DUKE POWER COMPANY

Enclosed is our response to your request for additional information (Mr. Reyes letter of July 22, 1986). Also enclosed is a revised Amendment 10 proposal to our Topical Report which incorporates the above responses as necessary.

Enclosure 1: Response to Request for Additional Information

Enclosure 1
Response to Request for Additional Information
Duke Quality Assurance Program

TOPICAL REPORT
FIGURE 17.2 - 1
AMENDMENT 10

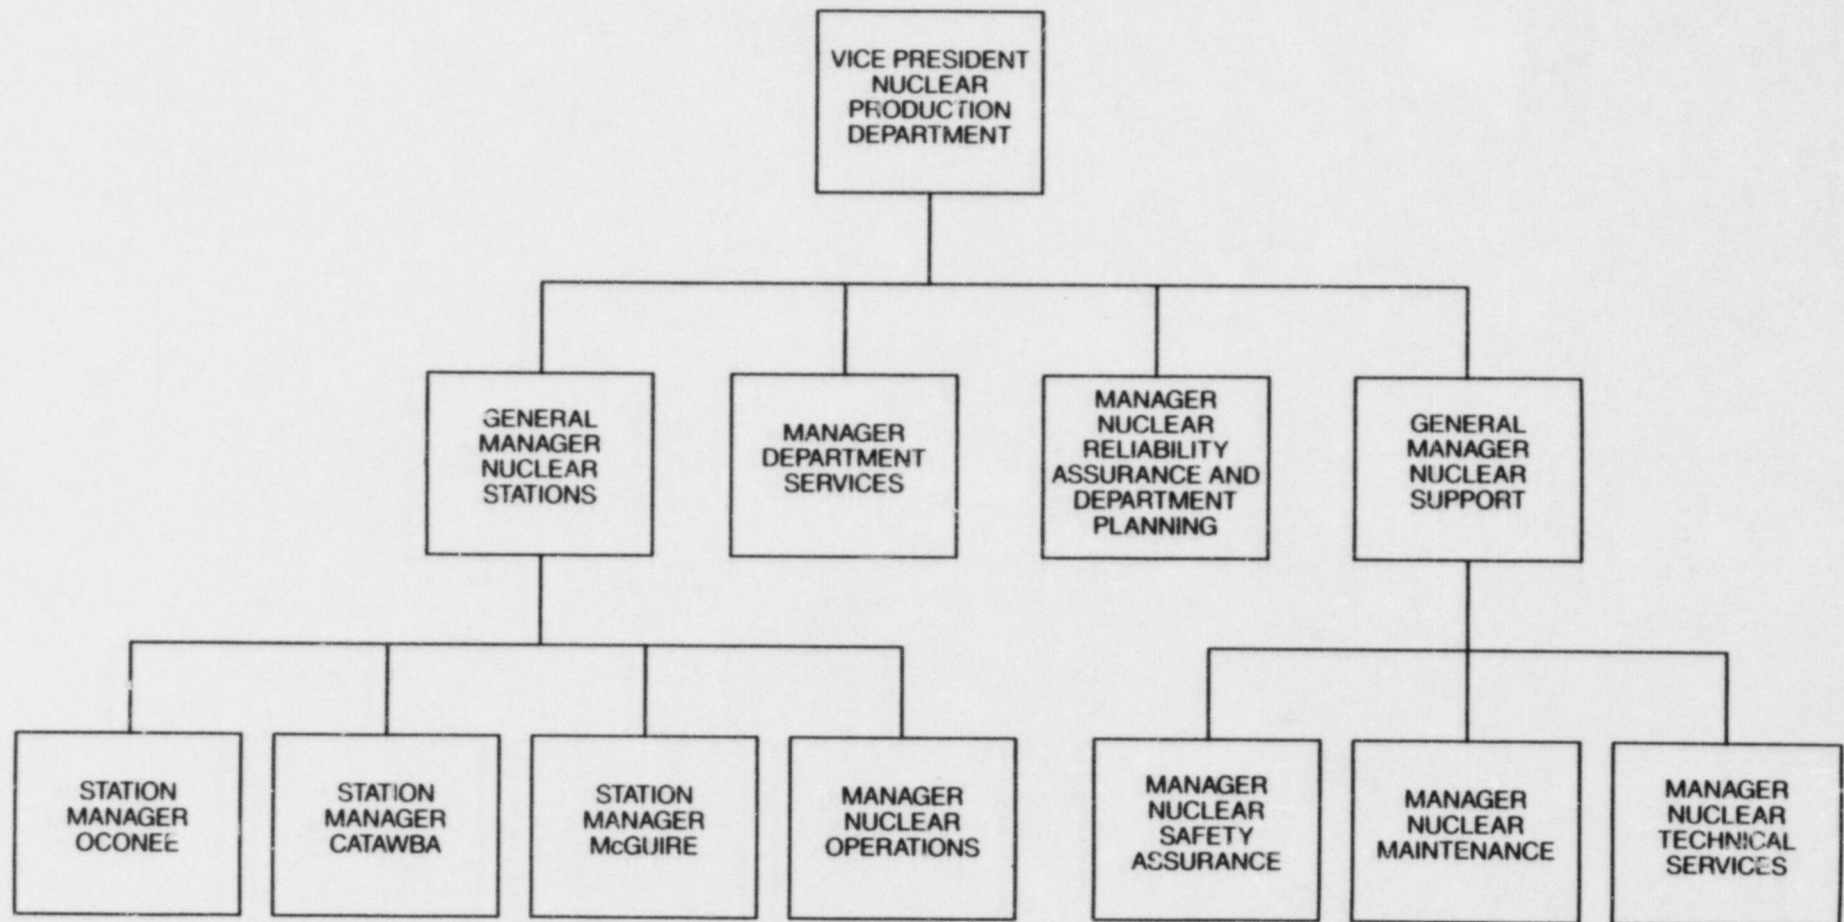
14. Figure 17.2-1

Explain where the duties of the Manager, Nuclear Engineering Services have been transferred.

The group was transferred to Design Engineering in the Mechanical Nuclear Division except the Licensing and Events Analysis Section which reports to the Manager, Nuclear Technical Services in the Nuclear Production Department.
